**ADDENDUM NO. 1**

**DATE:** April 1, 2021

**RELOCATABLE CLASSROOMS AT CLOVIS EAST HIGH SCHOOL  
& SITE IMPROVEMENTS**

**G.A. PROJECT NO. 2003A**

# ENLARGED SITE PLAN

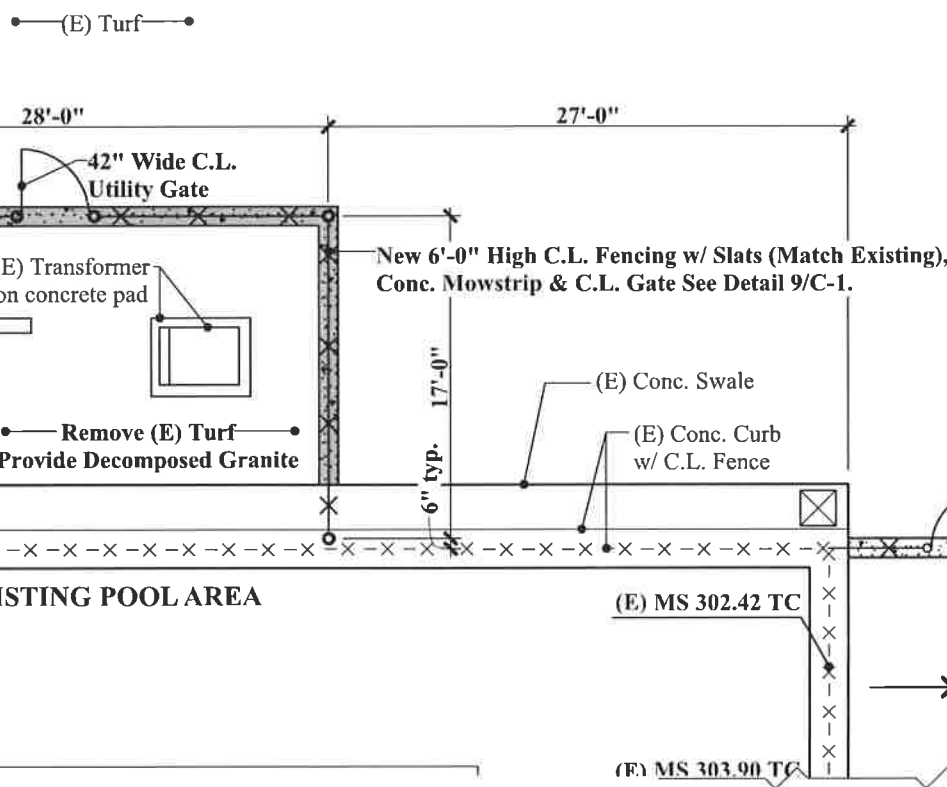
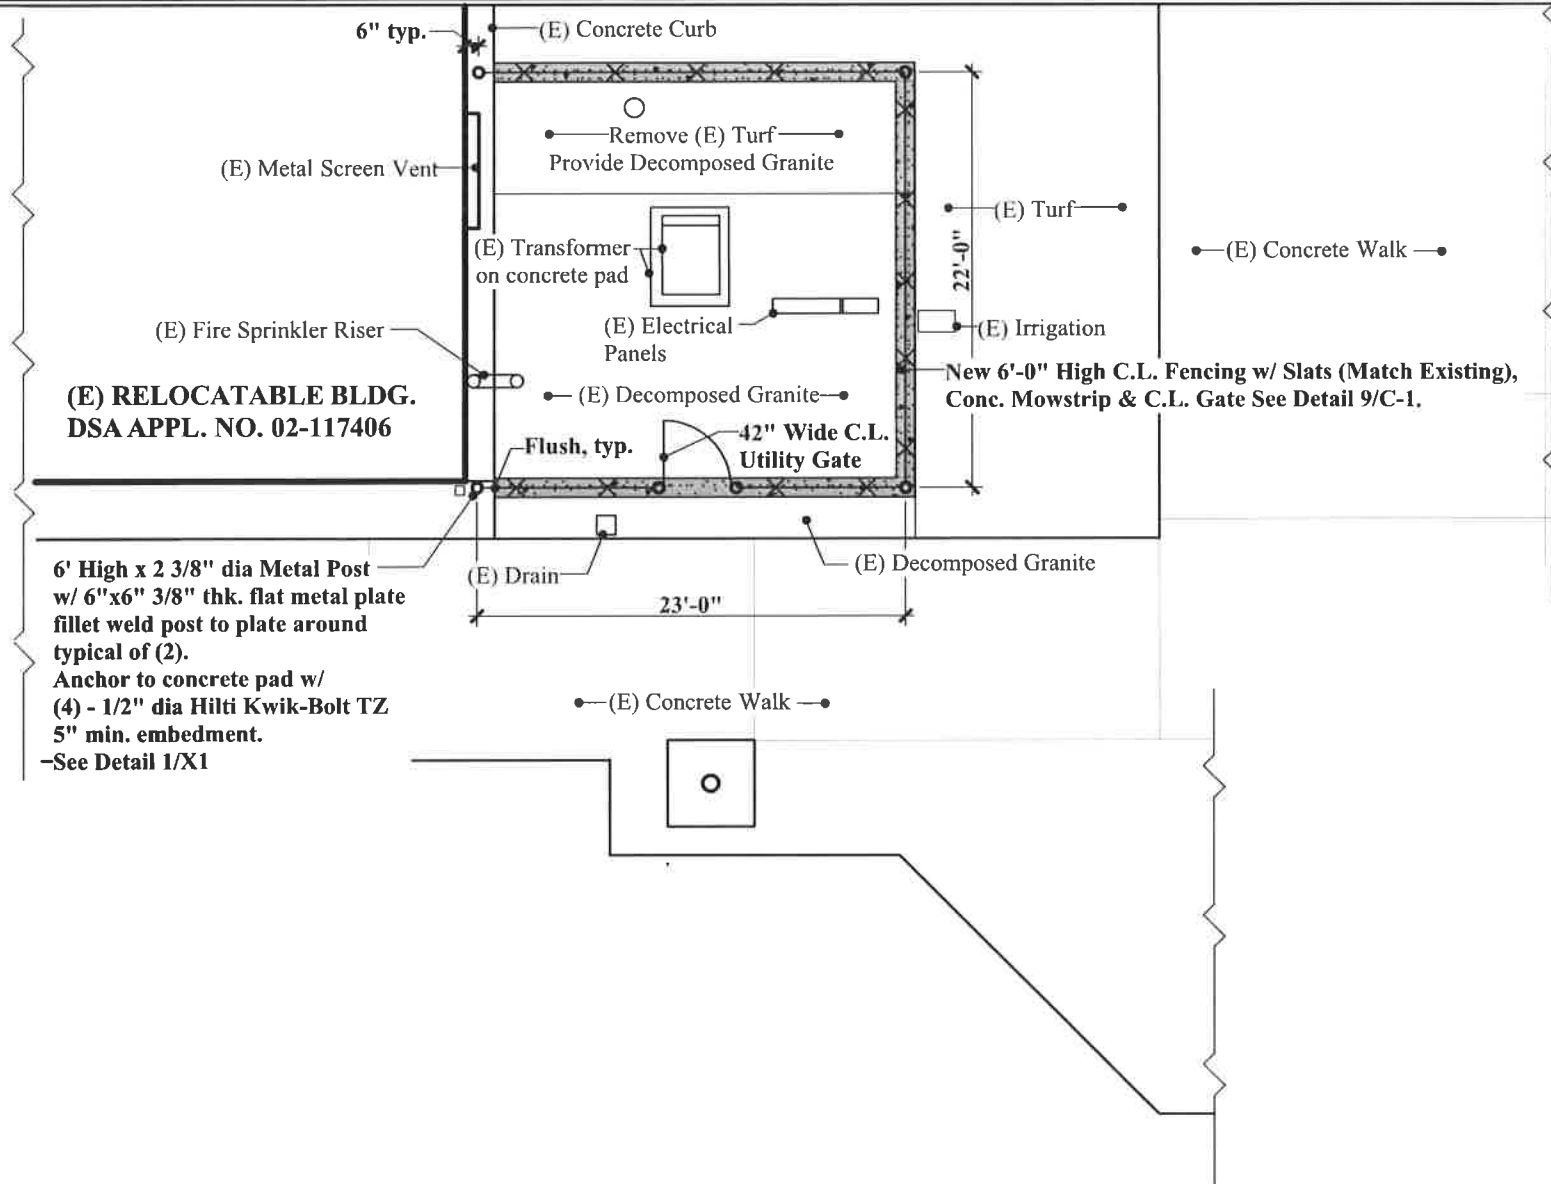
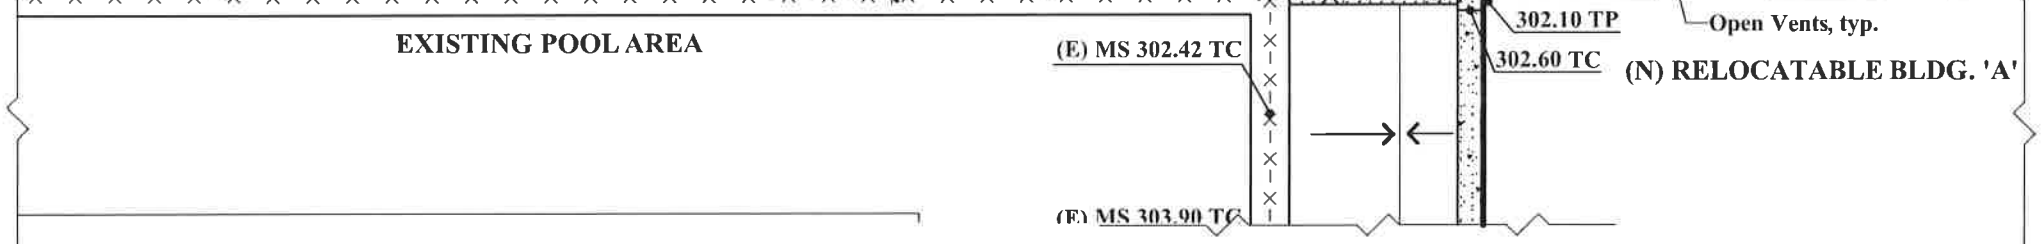
Incorporate attached Sheet X1 into the project.

Install Chain Link Fencing with Slats & Concrete Mowstrips to enclose existing site utility equipment.
